# Glades Estate Residential Subdivision

State Significant Development Modification Assessment  
(MP06\_0143 MOD 4)

November 2020

**Figure 4 |** Approved Bulk Earthworks Plan - Central Corridor (Source: Proponent’s Environmental Assessment – November 2007)

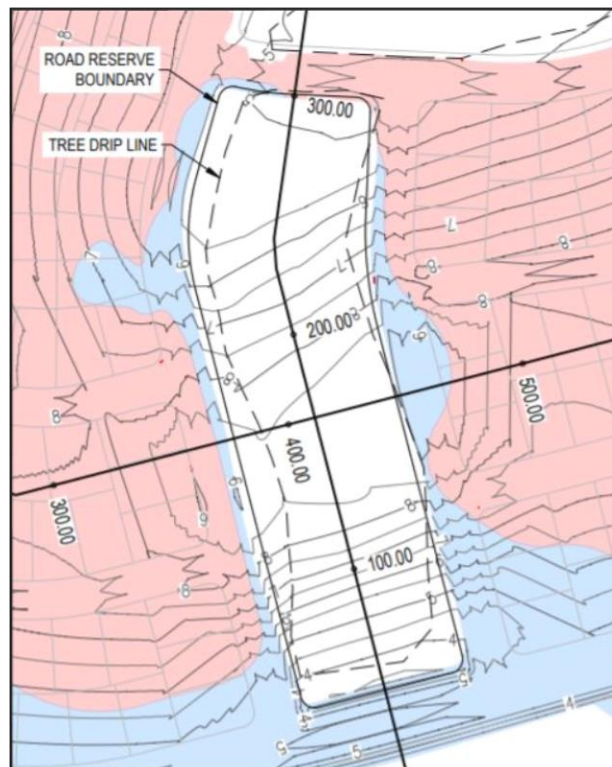
Despite the increased extent of cut and fill on land adjacent to the vegetated central corridor, it is not considered that the proposal as modified will result in unacceptable impacts on vegetation within the corridor, over those already approved under the original consent. **Figure 4** demonstrates approved earthworks along the southern, northern and eastern boundaries.

The location of the adjoining road reserves were approved under the original consent. As demonstrated in **Figure 4**, earthworks approved on the northern and eastern boundaries under the original approval are situated in close proximity to the location of the tree drip lines on the northern and eastern boundaries, demonstrated in **Figure 5**.

The Department has formed the view that the impact of the amended bulk earthworks on the central corridor is acceptable given condition B15 applies pursuant to the original project approval. However, in keeping with the advice provided by BCD and Council, with recommendations that condition B15 be updated to reflect Coffs Harbour City Council DCP Appendix 2, rather than the former Department of Natural Resources document, to ensure consistent and appropriate revegetation of the southern and western boundaries.

**Figure 6 | Central Corridor Section (West to East) (Source: Proponent's RtS – 13 August 2020)**

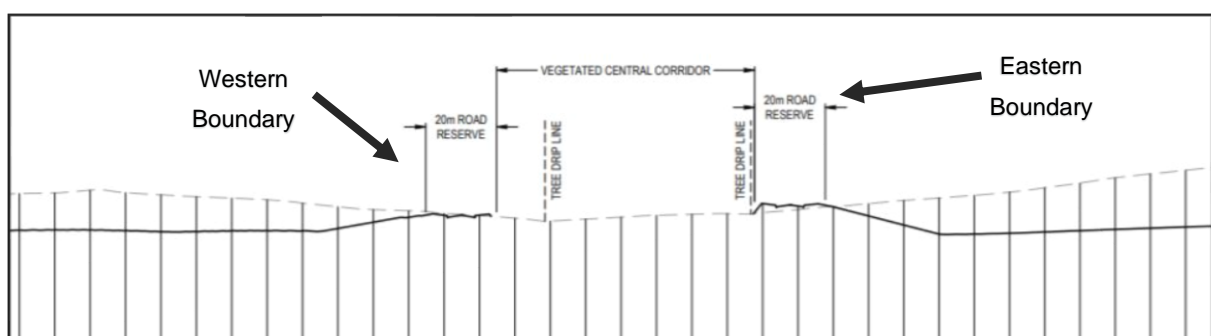
As a result of this modification, works in the location of the tree drip lines on the northern and eastern boundaries relate specifically to kerb and gutter requirements for the approved roadway (**Figures 6 & 7**). These minor impacts to vegetation however, can be suitably offset through revegetation in accordance with the Vegetation Management Plan (VMP) along the setback area of the western boundary of the corridor.

In regard to the Southern Boundary, the sections show that a batter would be situated on the southern boundary and slightly encroach into the central corridor. However as demonstrated in **Figure 3**, this batter would not encroach on the tree drip line. Revegetation of the batter would also be required as part of the VMP (condition B15 of the consent).
